State of New Mexico  
 Energy, Minerals and Natural Resources

WELL API NO. <b>30-015-22016</b>
5. Indicate Type of Lease STATE <input checked="" type="checkbox"/> FEE <input type="checkbox"/>
6. State Oil & Gas Lease No. <b>B-2071</b>
7. Lease Name or Unit Agreement Name <b>Walker State</b>
8. Well Number <b>4</b>
9. OGRID Number <b>229137</b>
10. Pool name or Wildcat <b>Artesia Queen GB SA</b>

**SUNDRY NOTICES AND REPORTS ON WELLS**  
 (DO NOT USE THIS FORM FOR PROPOSALS TO DRILL OR TO DEEPEN OR PLUG BACK TO A DIFFERENT RESERVOIR. USE "APPLICATION FOR PERMIT" (FORM C-101) FOR SUCH PROPOSALS.)

2. Name of Operator  
**COG Operating LLC**

CURRENT WELLBORE DIAGRAM

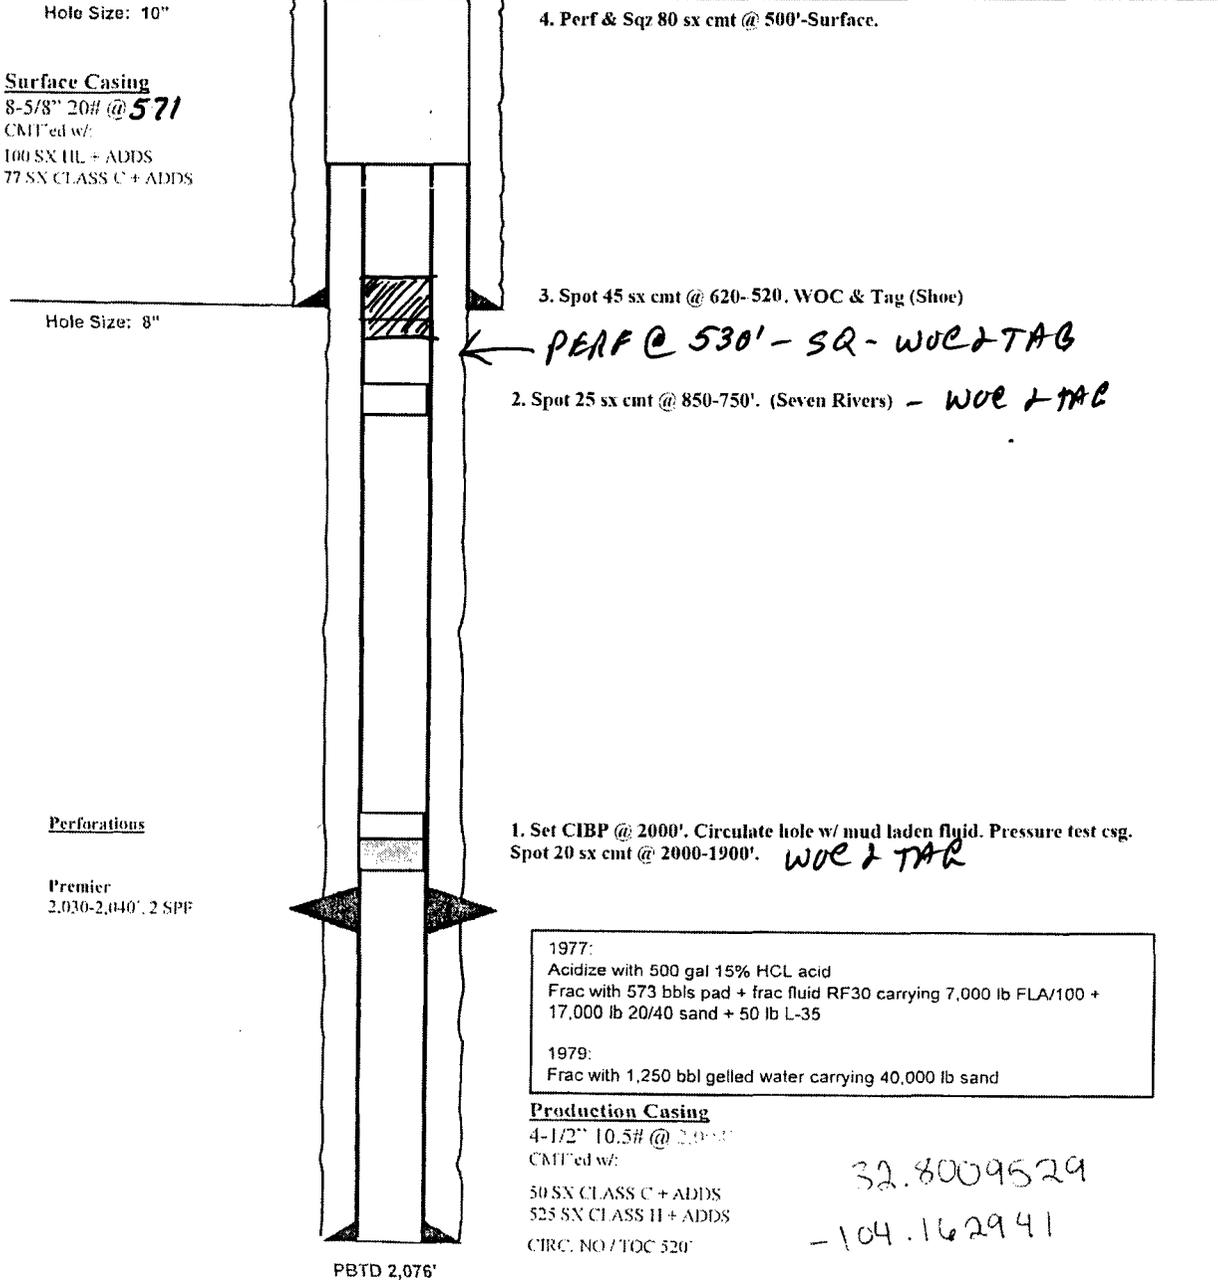
1. Set CIBP @ 2000'. Circulate hole w/ mud laden fluid. Pressure test csg. Spot 20 sx cmt @ 2000-1900' - *WOC & TAG*
2. Spot 20 sx cmt @ 850-750'. (Seven Rivers) - *WOC & TAG*
3. Spot 20 sx cmt @ 620-520'. WOC & Tag (shoe)
4. Perf & Sqz 80 sx @ 500'-Surface *PERF @ 530' - SQ - WOC & TAG*
5. Cut off well head, weld on Dry Hole Marker.

**★ SEE ATTACHED COA-5**

4. Perf & Sqz 80 sx cmt @ 500'-Surface.

3. Spot 45 sx cmt @ 620-520. WOC & Tag (Shoe)

2. Spot 25 sx cmt @ 850-750'. (Seven Rivers) - WOC & TAG

← PERF @ 530' - SQ - WOC & TAG

1. Set CIBP @ 2000'. Circulate hole w/ mud laden fluid. Pressure test csg.  
 Spot 20 sx cmt @ 2000-1900'. WOC & TAG
